SIB 72 04 17

FALSE WARNINGS THAT THE FRONT PASSENGER SEAT IS OCCUPIED WITHOUT THE SEAT BELT BUCKLED

This Service Information Bulletin (Revision 10) replaces SI B72 04 17 dated **September 2019**.

What's New (Specific text highlighted):

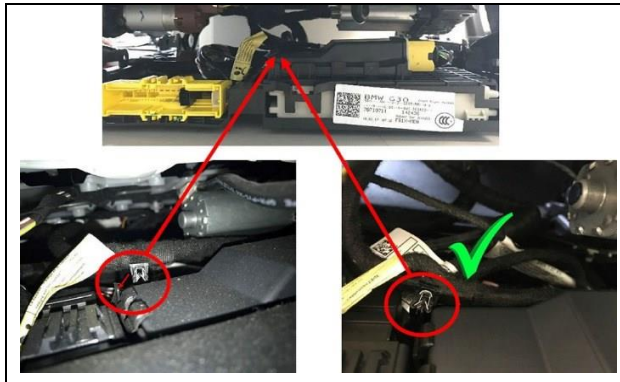
8. Secure the loose clip attached to cables, as shown.

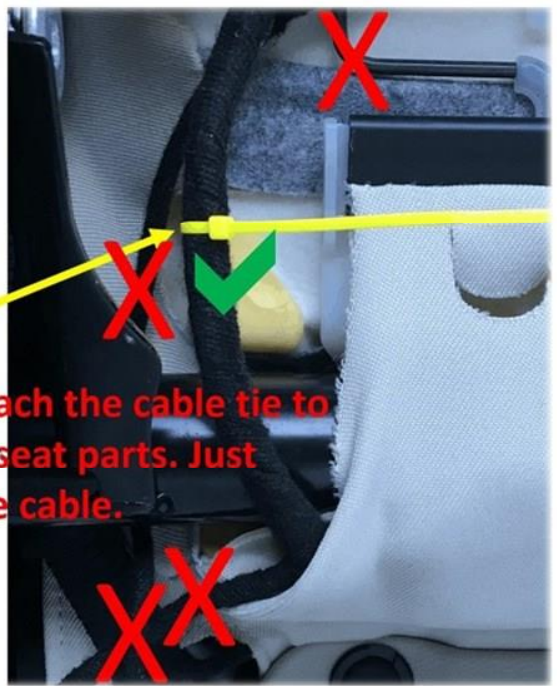
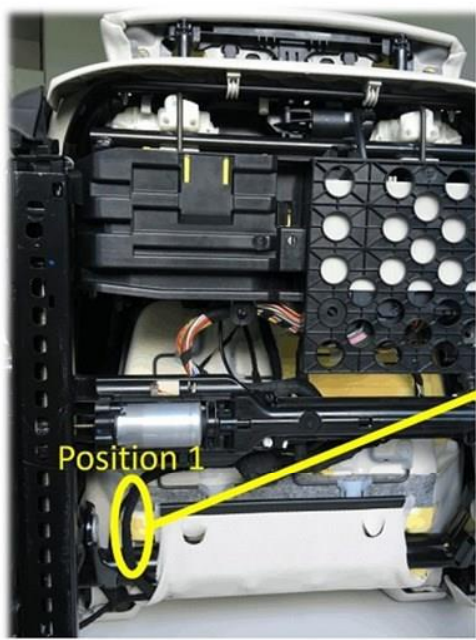
For cable tie position, review the: <https://tinyurl.com/V520218>

Do not attach the cable tie to any other seat parts. Just around the cable.

First cable tie position as shown in above photo

Secound cable tie position as shown in above photo

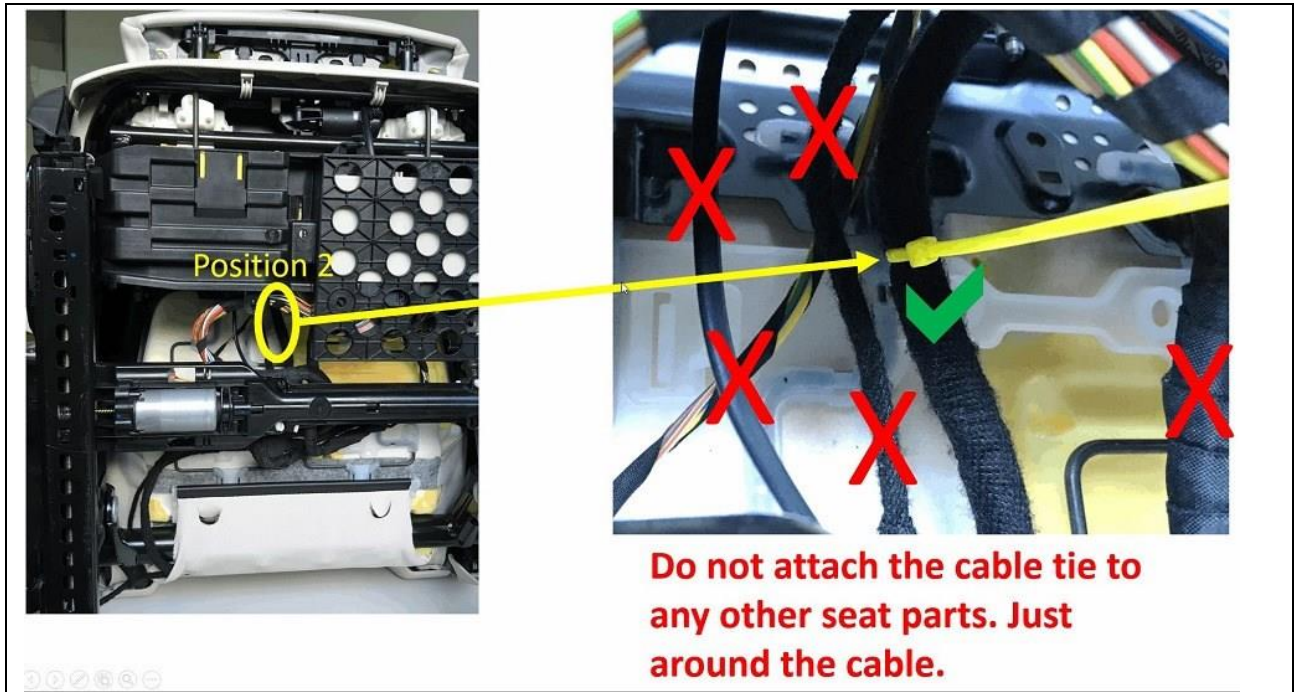
<p>UPDATE!</p> <p>9. With the tool shown in the picture, tie the cable tie only around the harness. To correctly tension the cable tie set the tool to 3.75</p>
--	---
